STATE OF NORTH CAROLINA
DEPARTMENT OF TRANSPORTATION

Subject: **Submittal of DCM Consistency Certification** for the proposed US 17 Improvements
From the Jacksonville Bypass to Drummer Kellum Road Jacksonville, Onslow County,
TIP U-4007, WBS 35008.1.1

Coastal Zone Consistency Certification Supporting Information for the NCDOT's Request to Construct the US 17 Improvements from the Jacksonville Bypass to Drummer Kellum Road of the City of New Jacksonville, in Onslow Counties (US 17 Improvements). NCDOT TIP U-4007.

Subject: Minutes from Interagency 4C Permit Drawing Review Meeting
On April 15, 2009 for U-4007A in Onslow County

PROJECT REFERENCE NO.	SHEET NO.
U-4007A	8
RW SHEET NO.	
ROADWAY DESIGN ENGINEER	HYDRAULICS ENGINEER

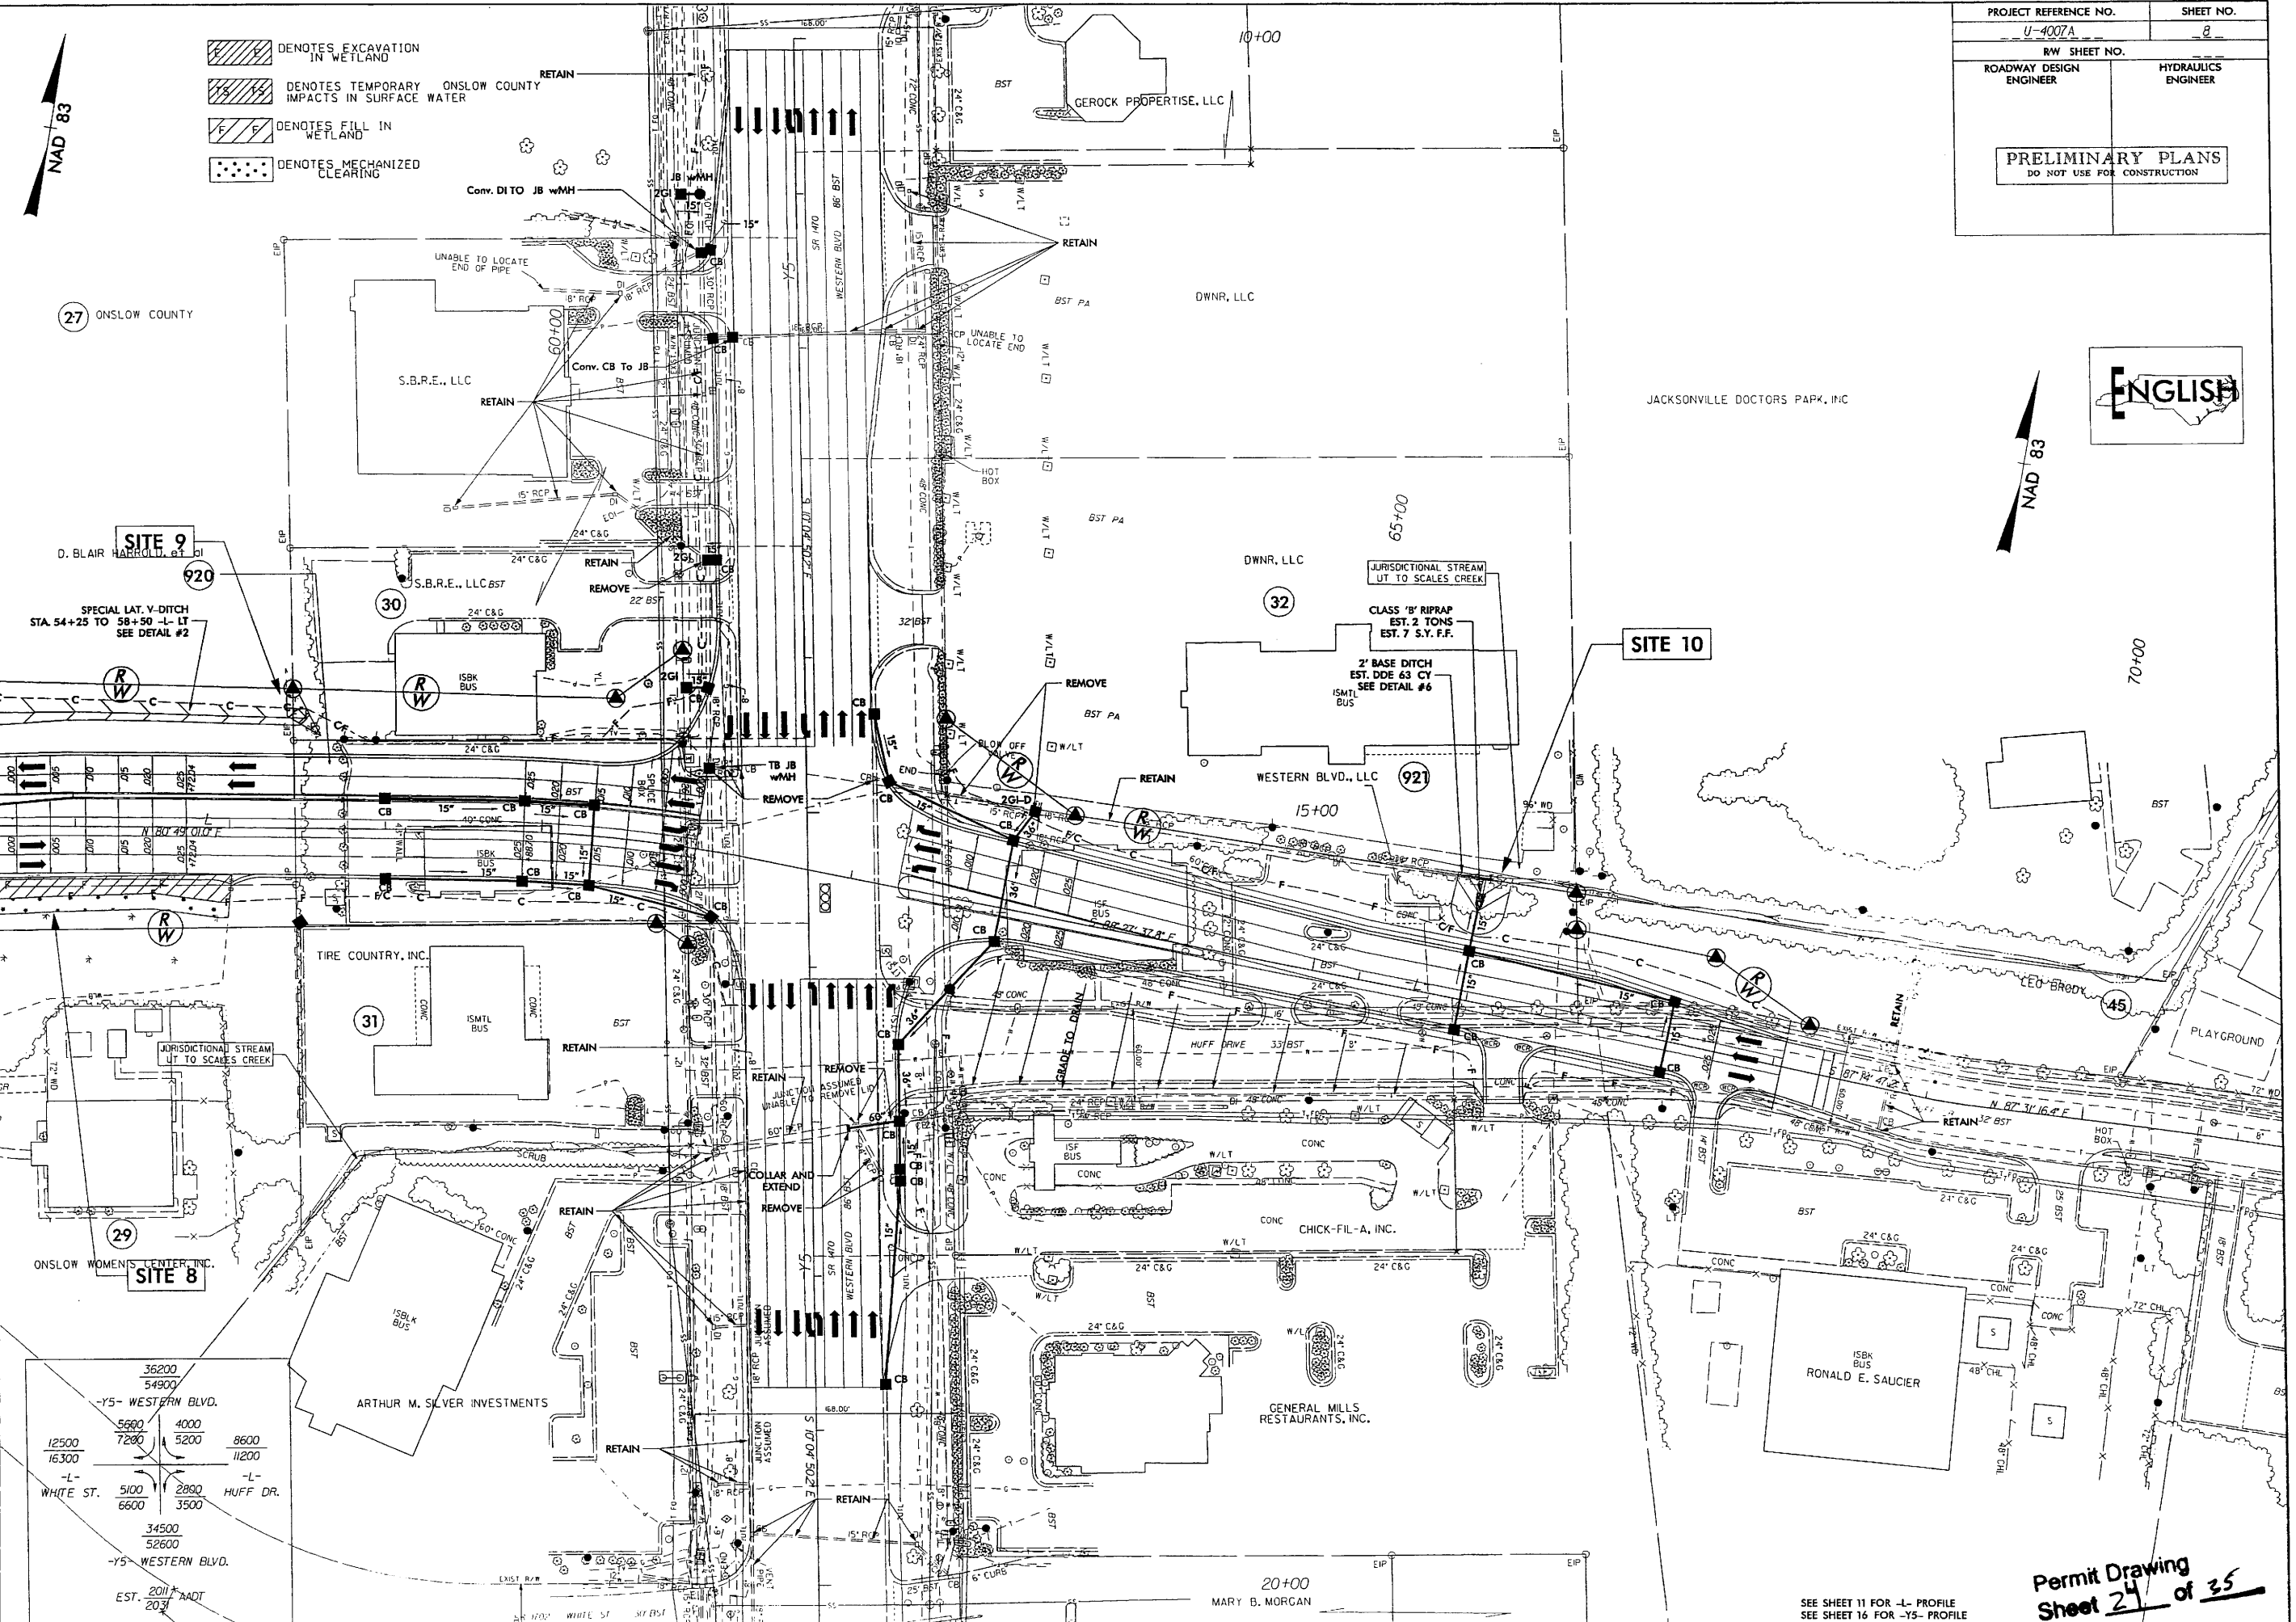
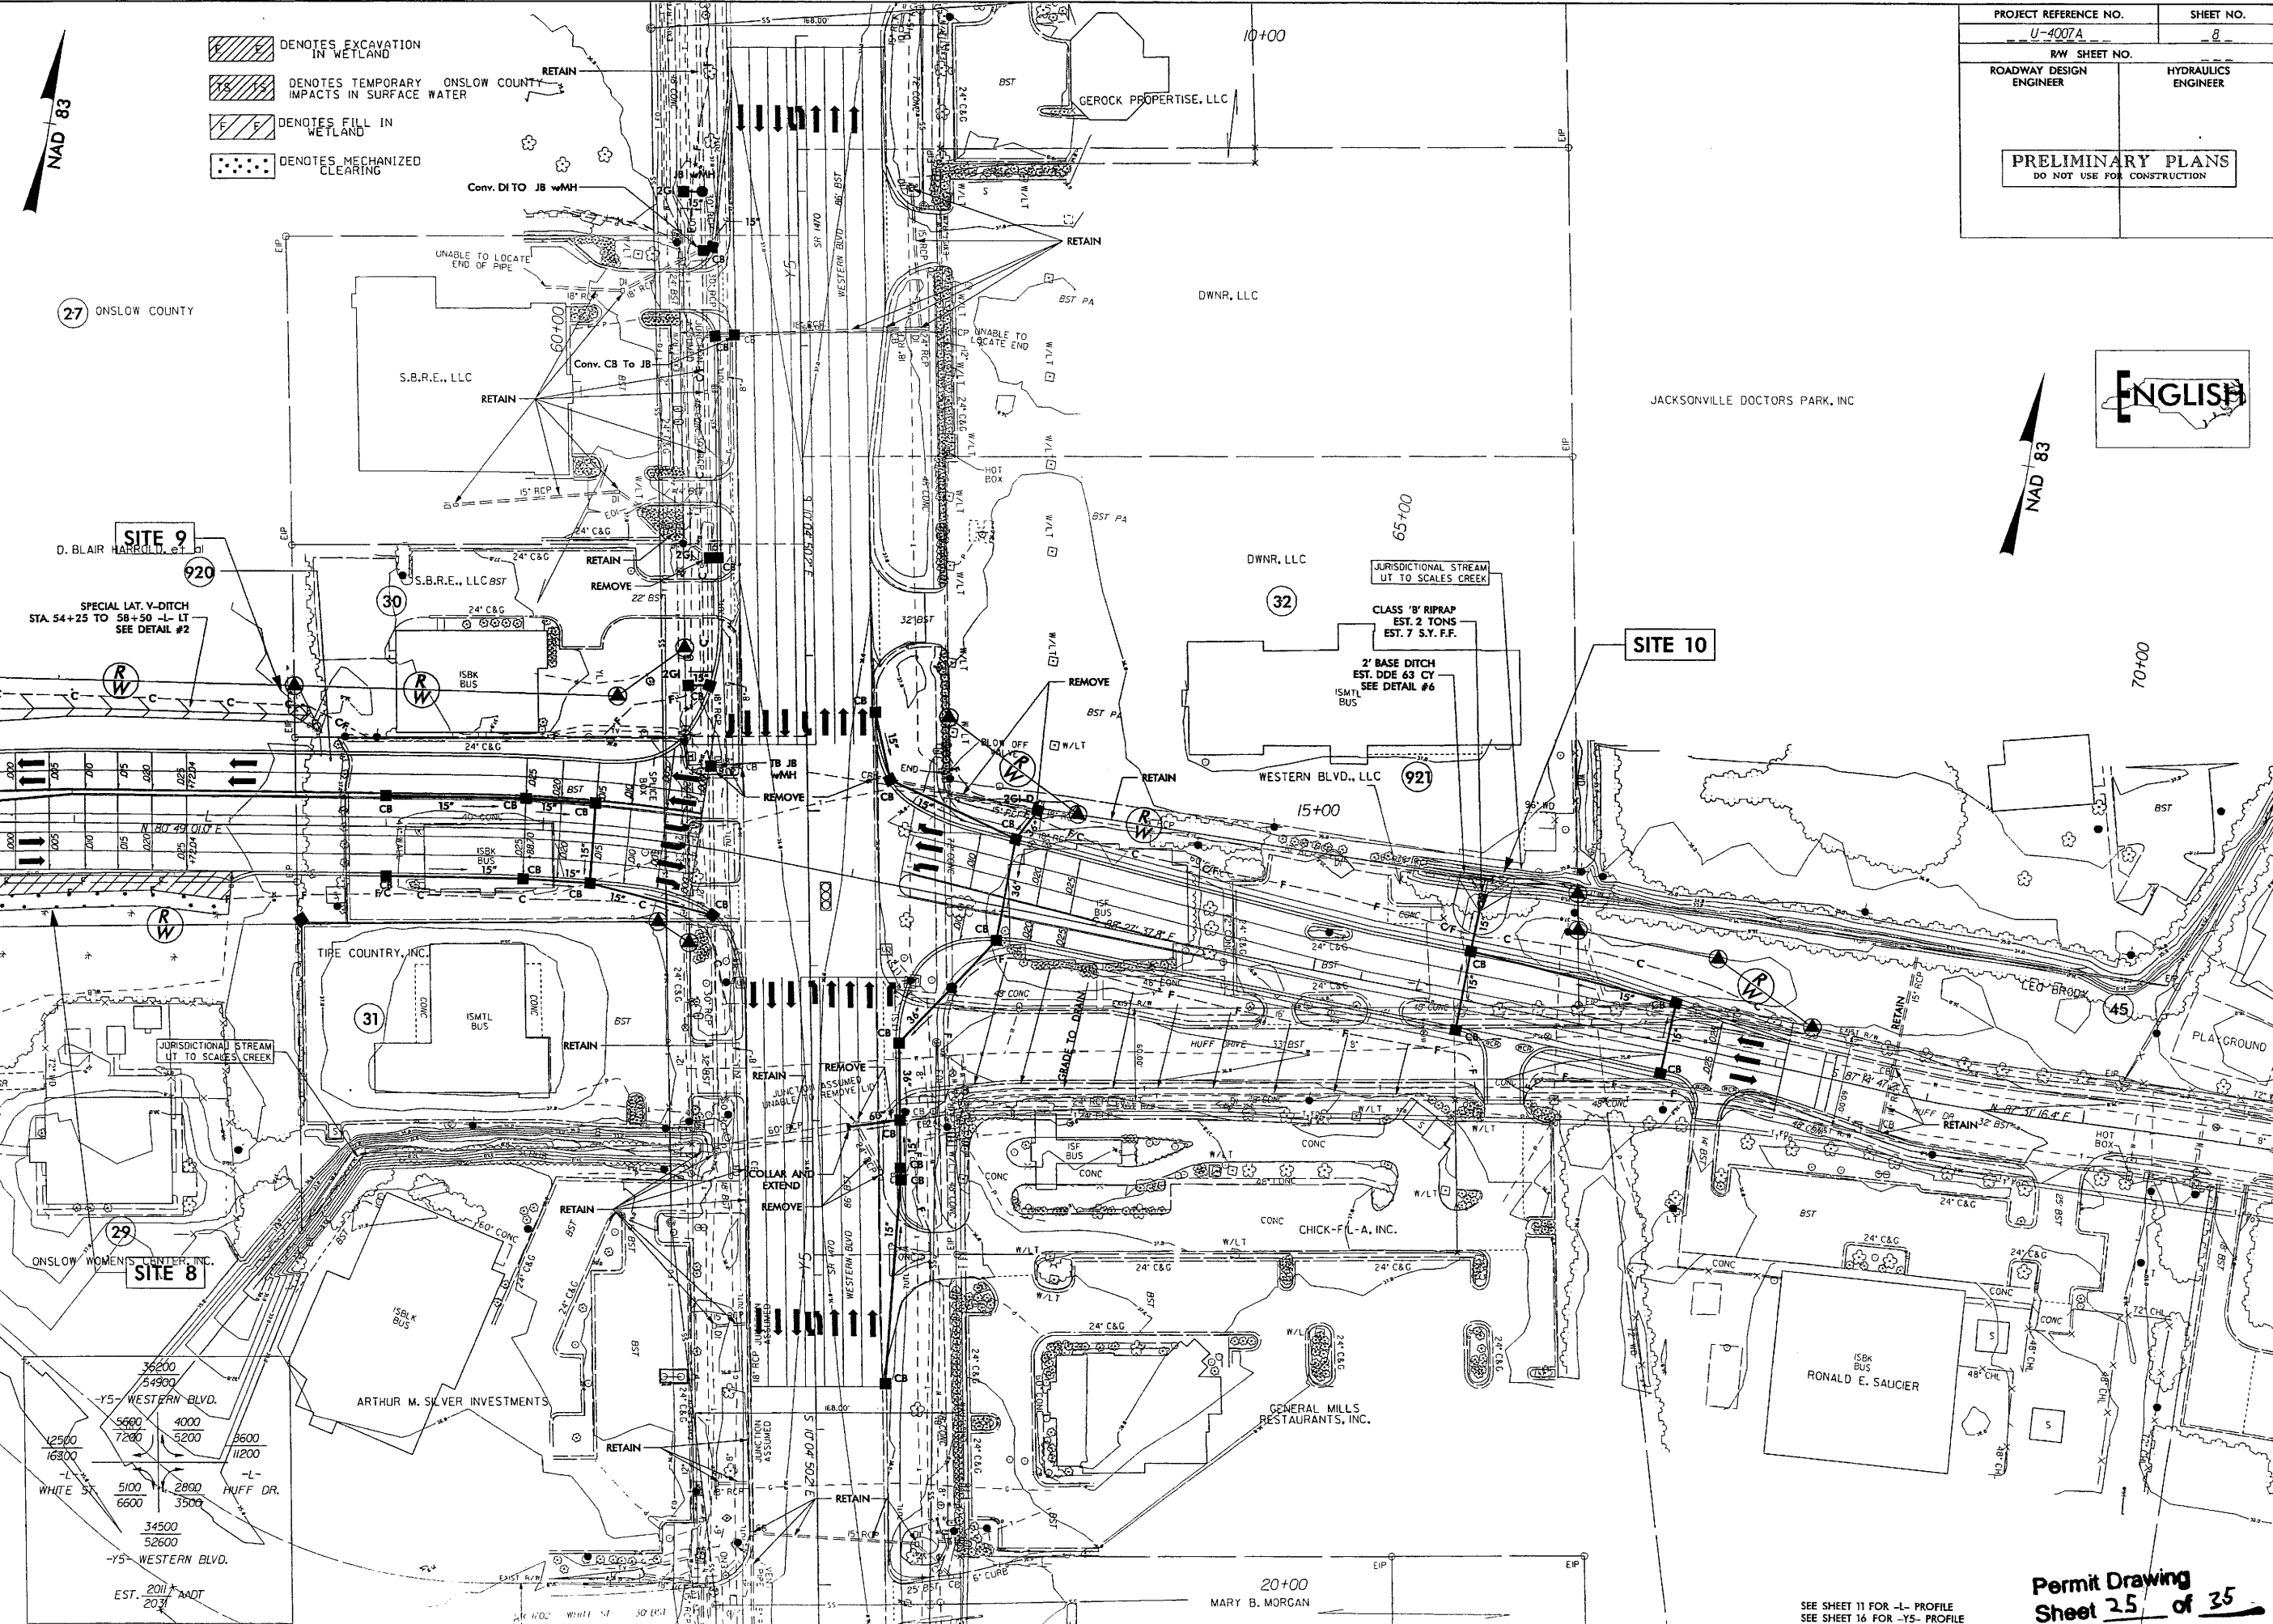
Mr. Dalton stated that a small wetland exists right of stations 55+00 to 58+00 –L-. This area is currently shown as cut, but the curb and gutter will be extended past the wetland to remove the cut ditch from the wetland area.

Mr. Dalton stated that there is a jurisdictional stream parallel to and north of Huff Drive. This stream enters an existing 36-inch RCP and exits the system from an existing 60-inch RCP on the west side of Western Boulevard. A portion of this system will be revised.

PROJECT REFERENCE NO. U-4007B	SHEET NO. 06
R/W SHEET NO.	
ROADWAY DESIGN ENGINEER	HYDRAULICS ENGINEER
Permit Drawing Sheet 13 of 56

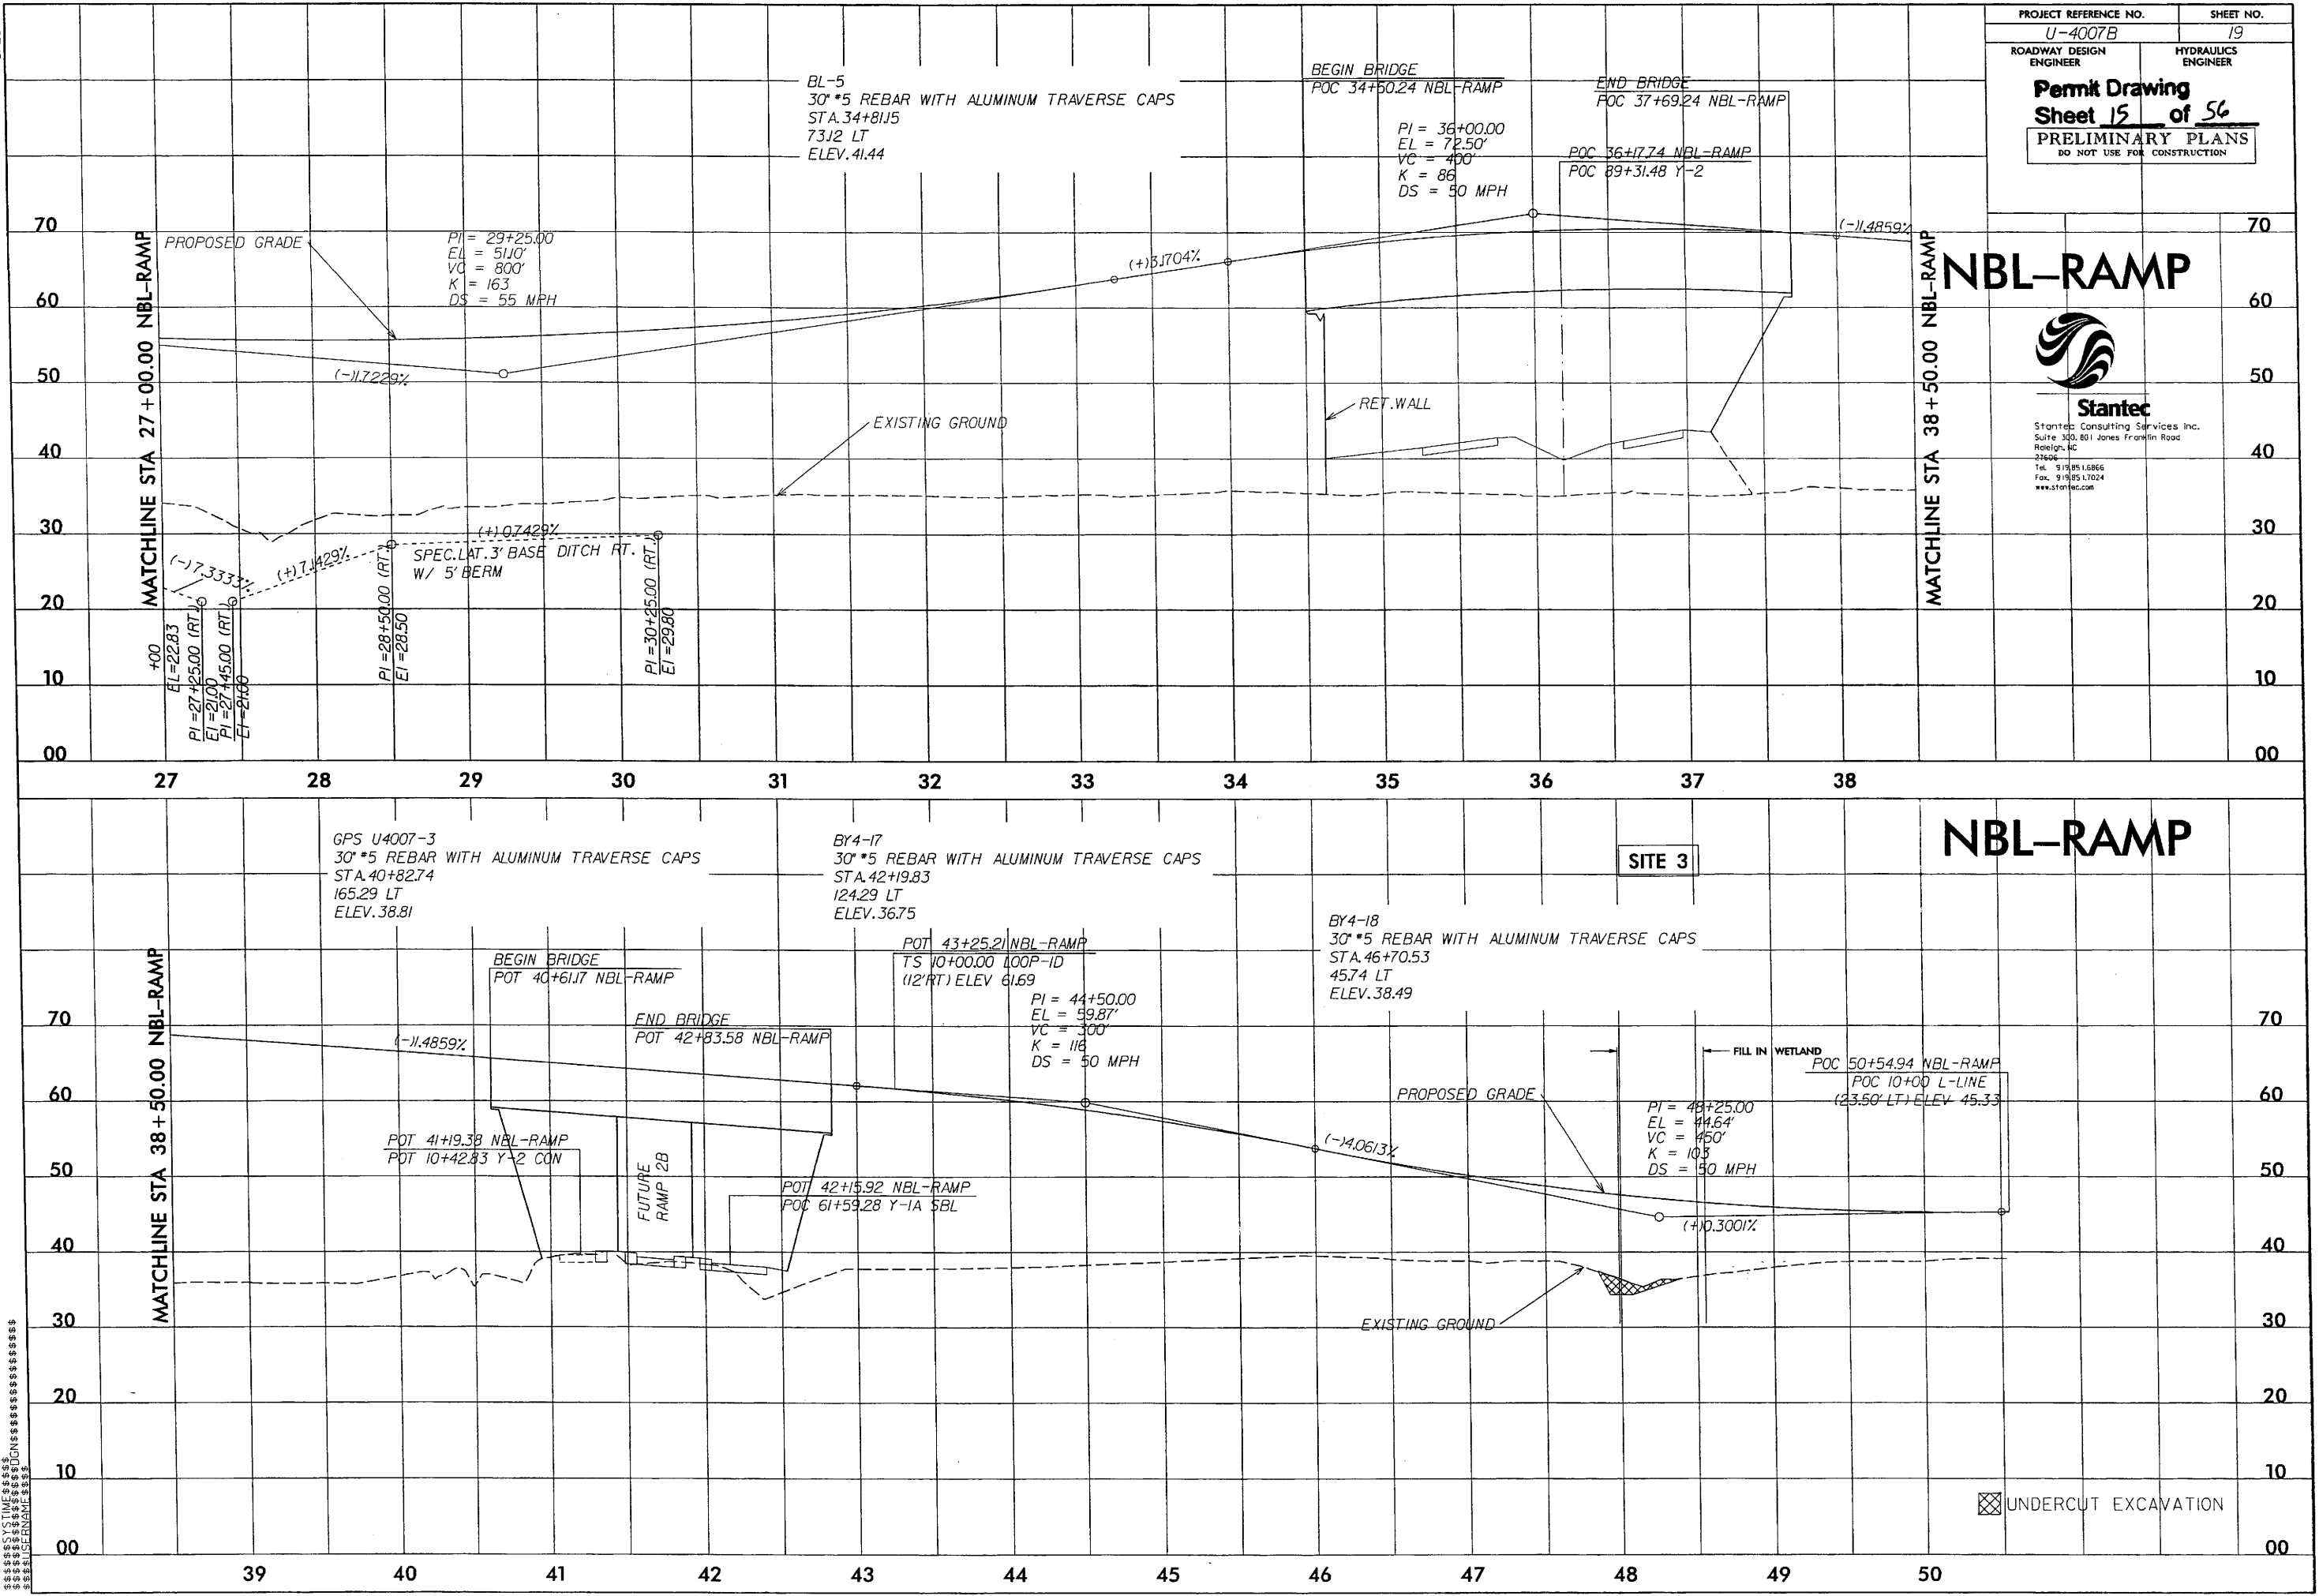
It was discussed to change the hatching for pavement and embankment removal on Hawkside Drive. Also add a note to "Remove Embankment to Natural Ground".
